The following letter and revised drawings respond to your review and comments for 53<sup>rd</sup> and Tennyson Row project at 4301 W. 53<sup>rd</sup> Ave, Log number PRC2020-00005. Responses are listed below in **red**. Please call or email if you have any questions or require additional information.

# 53RD AND TENNYSON ROW - LANDSCAPE PLAN

# Comment Response

The following letter responds to your plan review and comments for the project at **4301 W. 53<sup>rd</sup> Avenue, Denver, CO 80212**, Application #PRC2020-00005 and EGR2020-00007. Responses are listed below in **red**. Please call or email if you have any questions or require additional information.

LOT TYP.  
LANDSCAPE  
PLAN 1.2

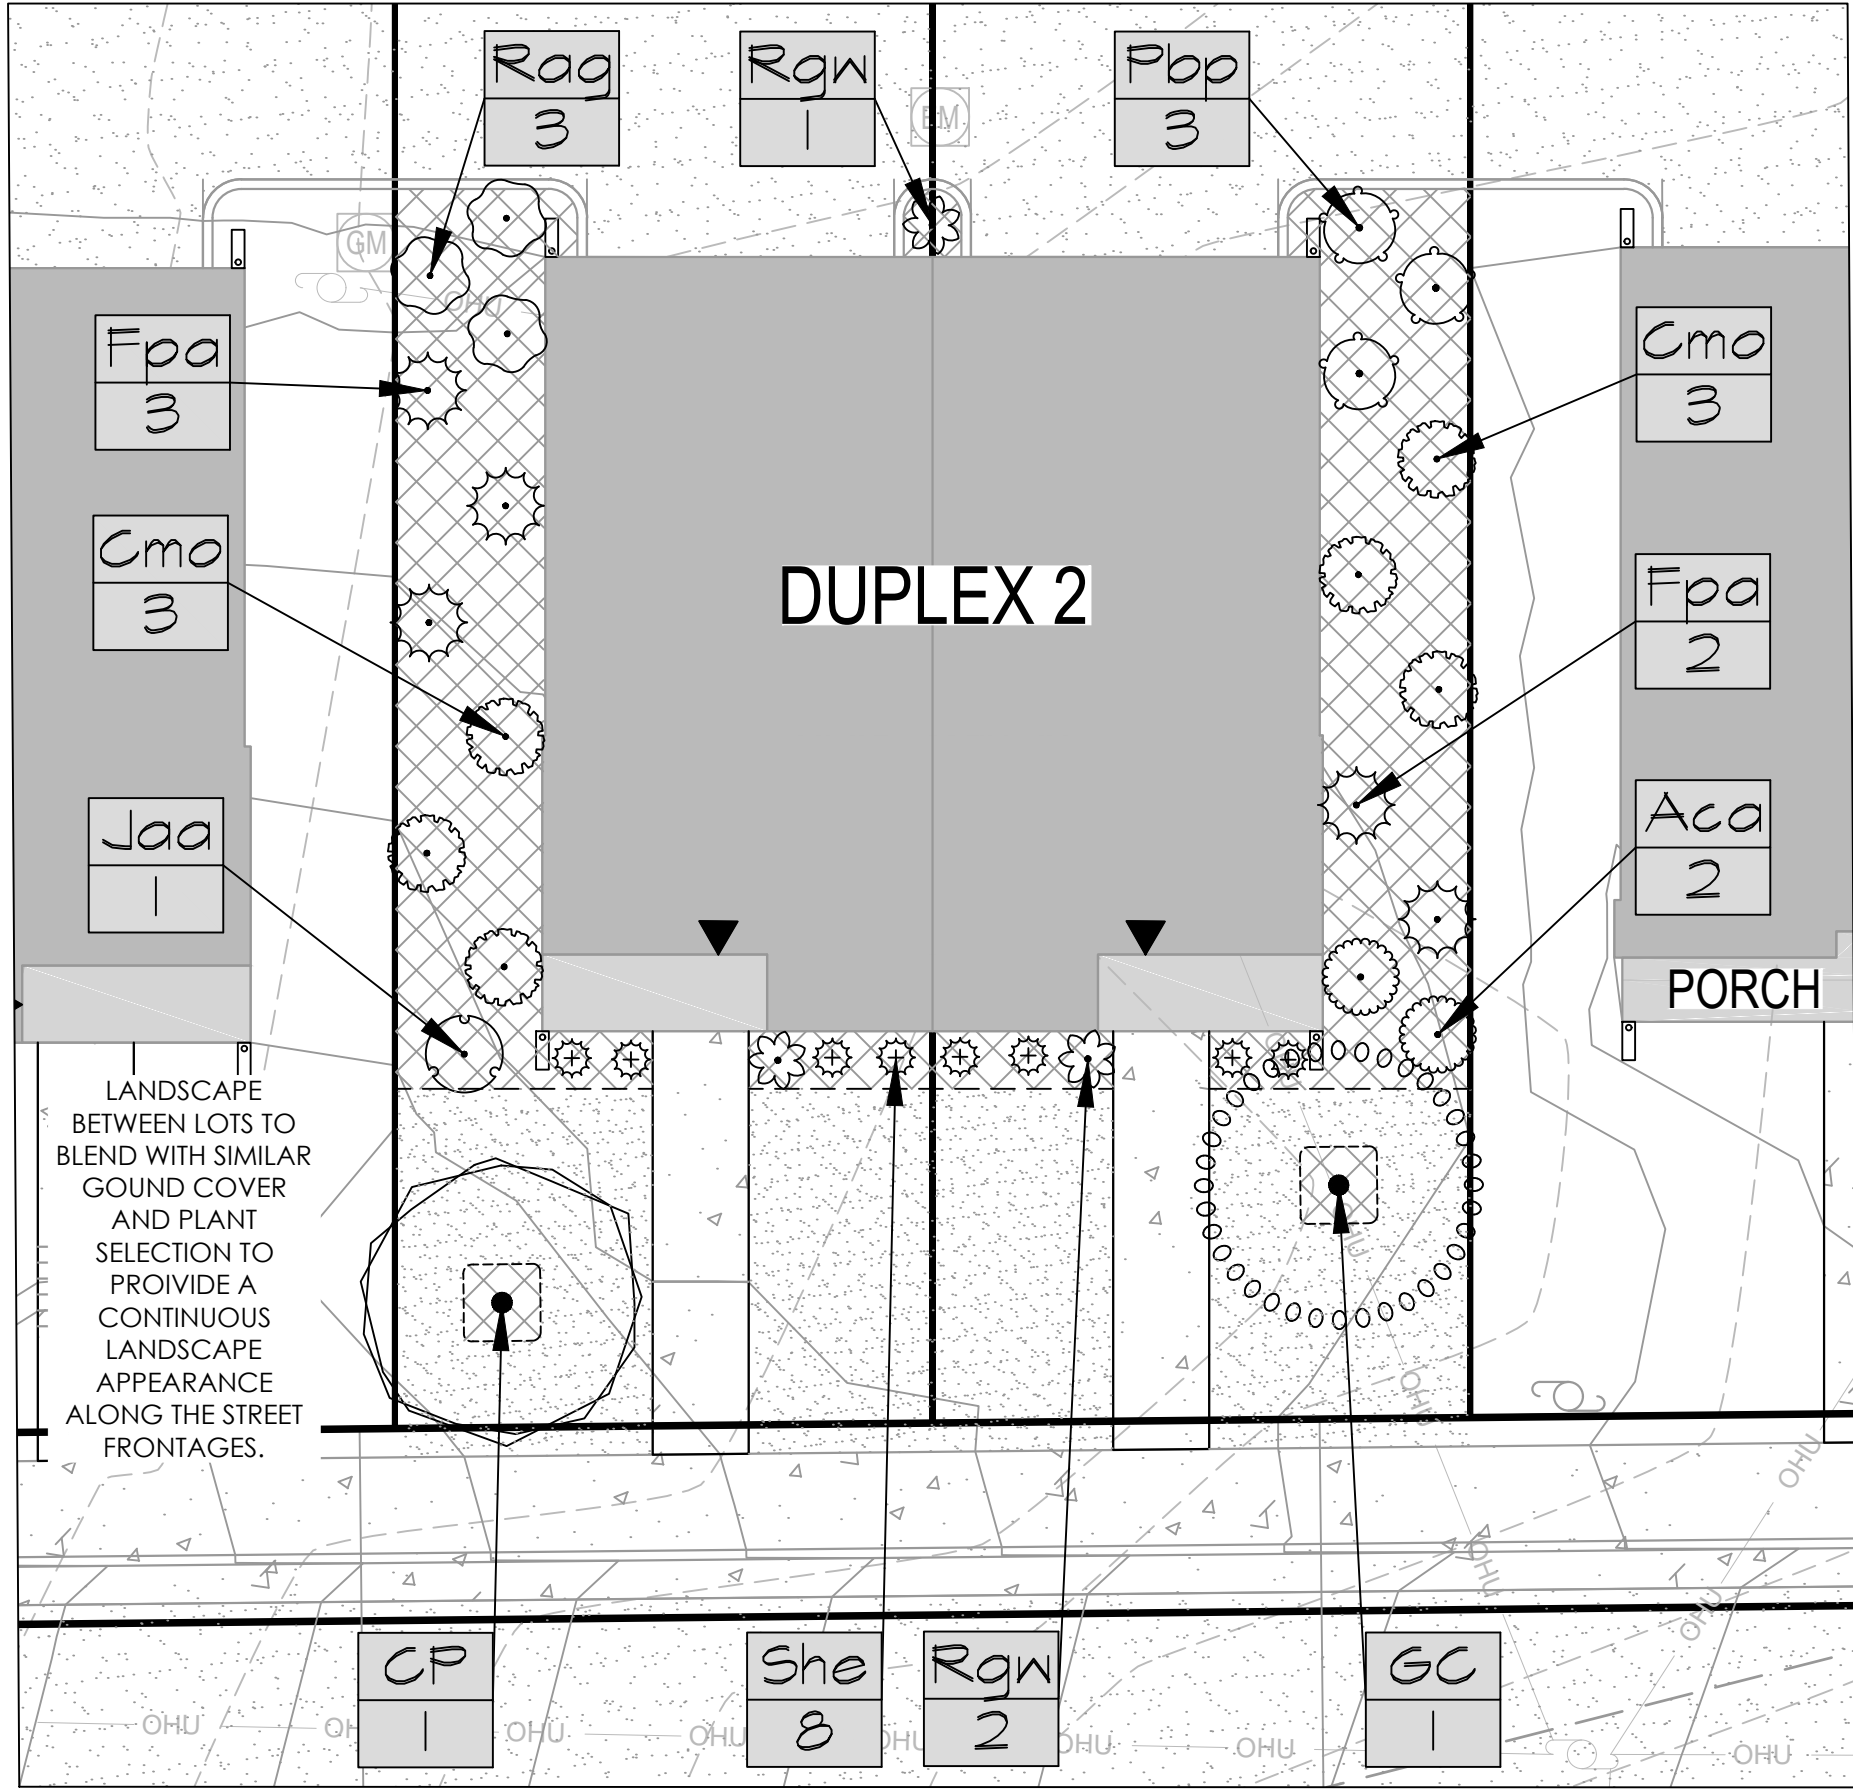
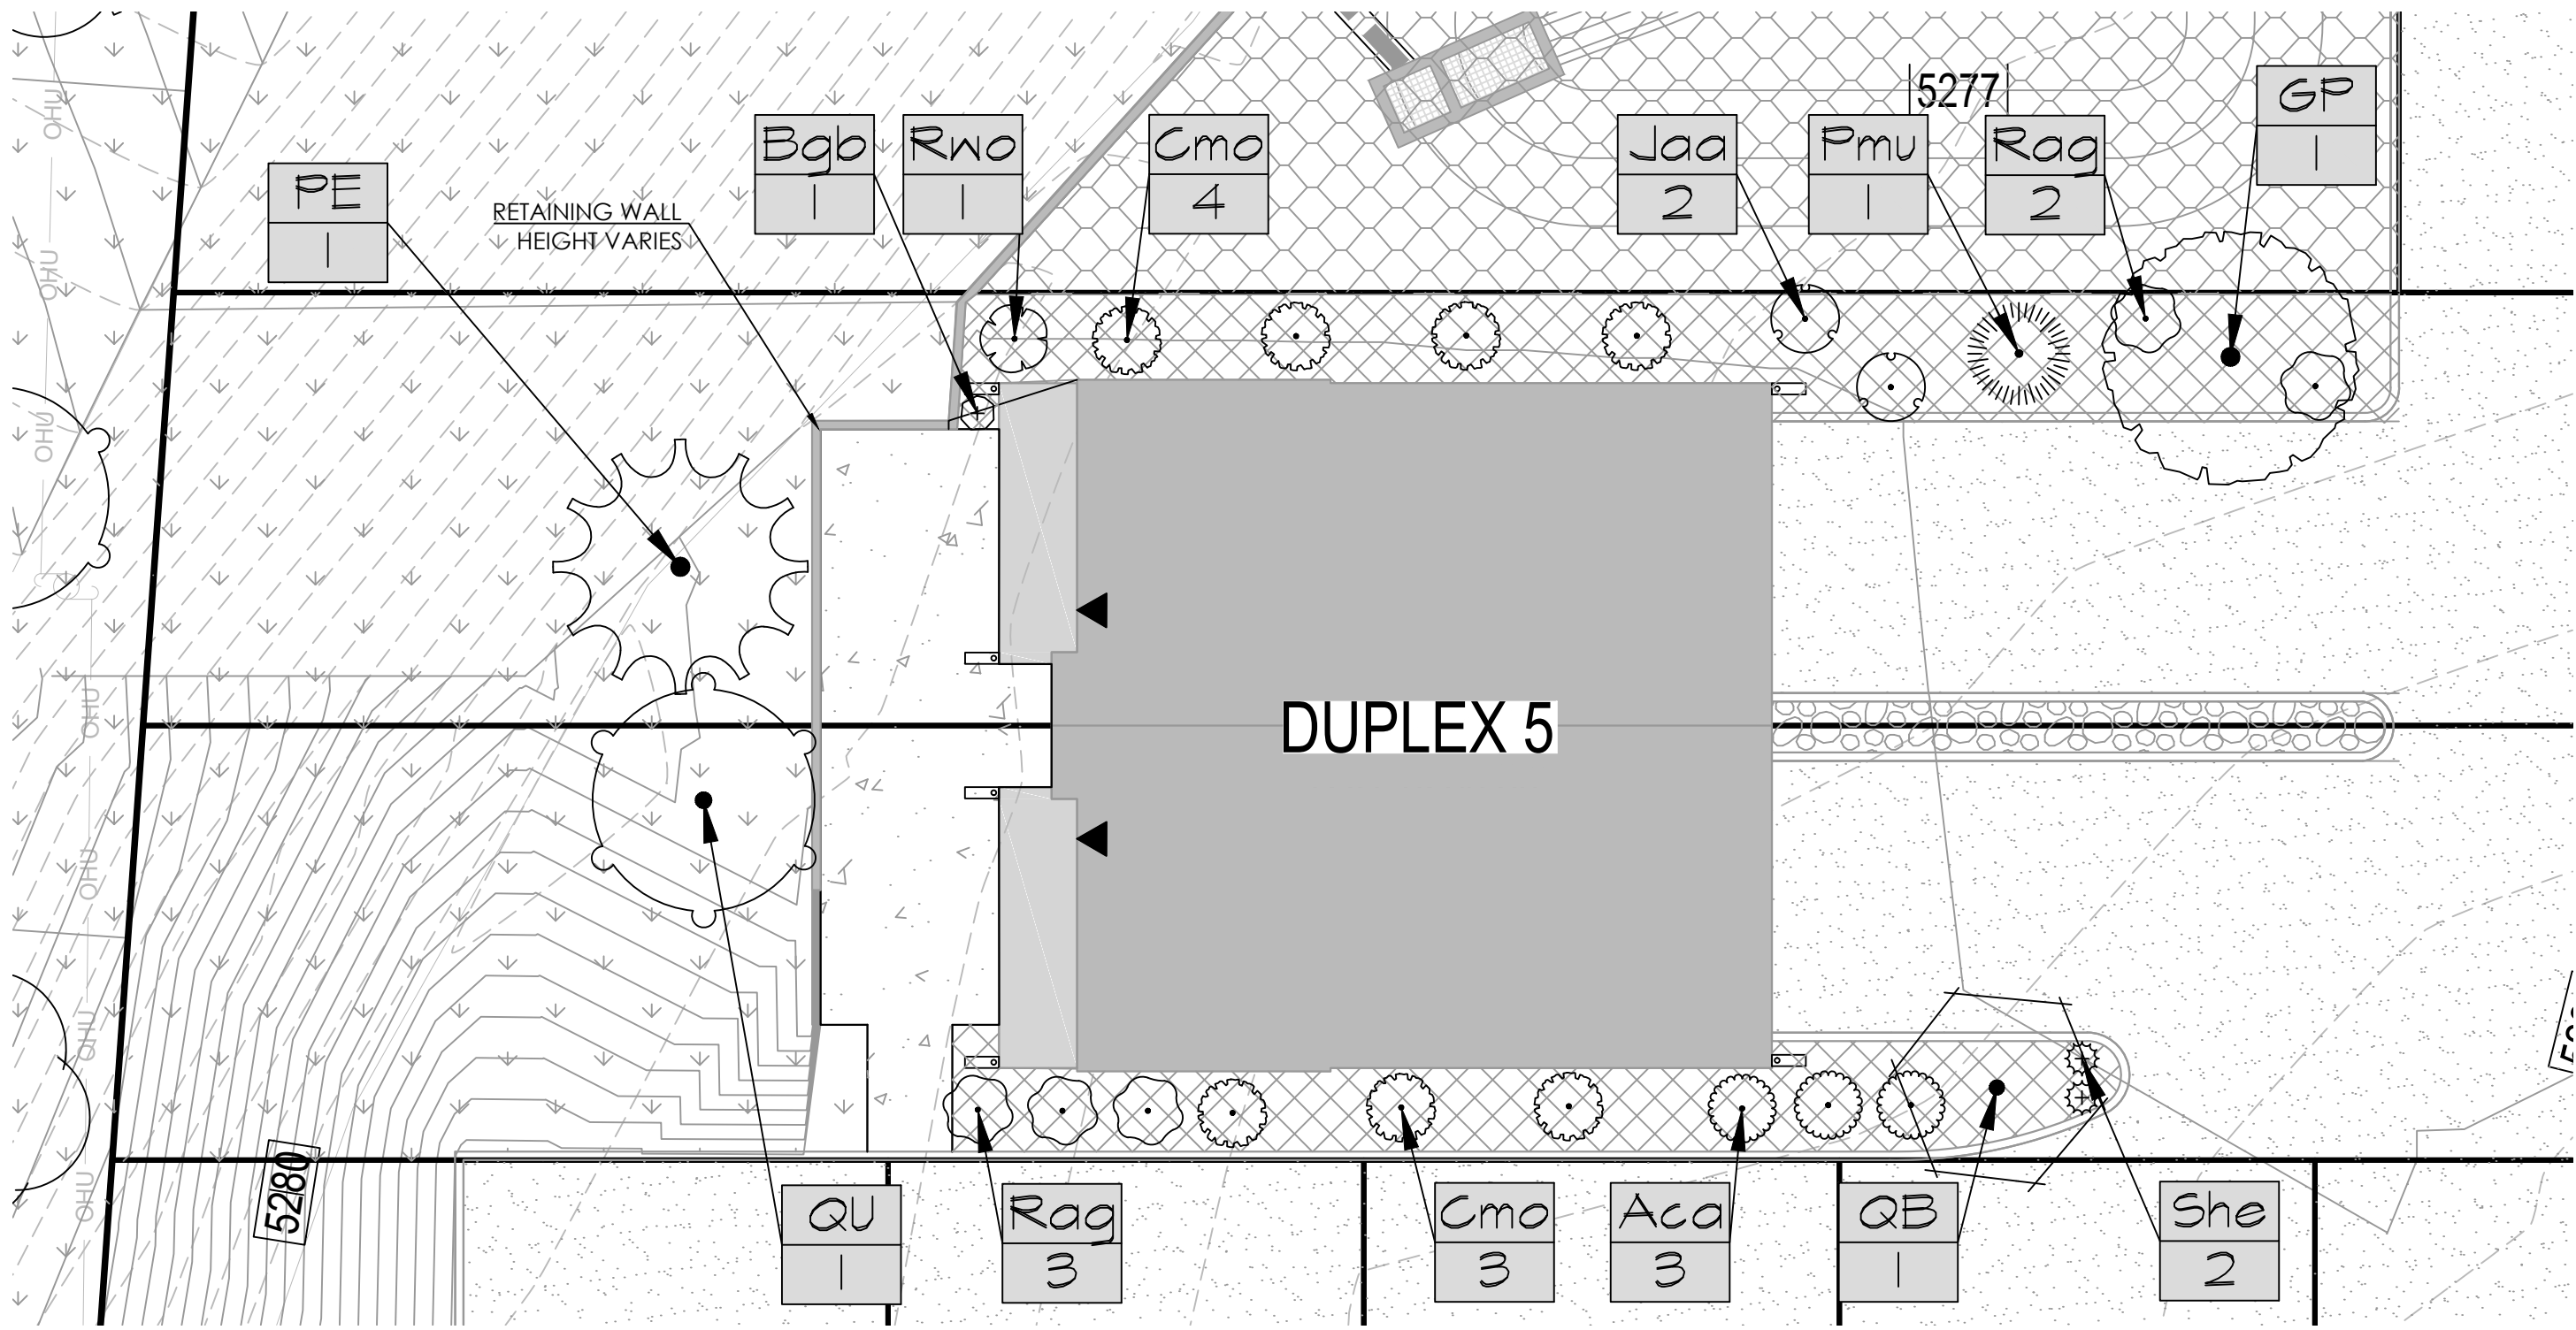
- iii. Please include individual lot calculations with Landscape Plan

*Response: Individual lot calculations have been included on the landscape plan.*

*Response: Three lot typical examples are included on Sheets LS-3 and LS-4.*
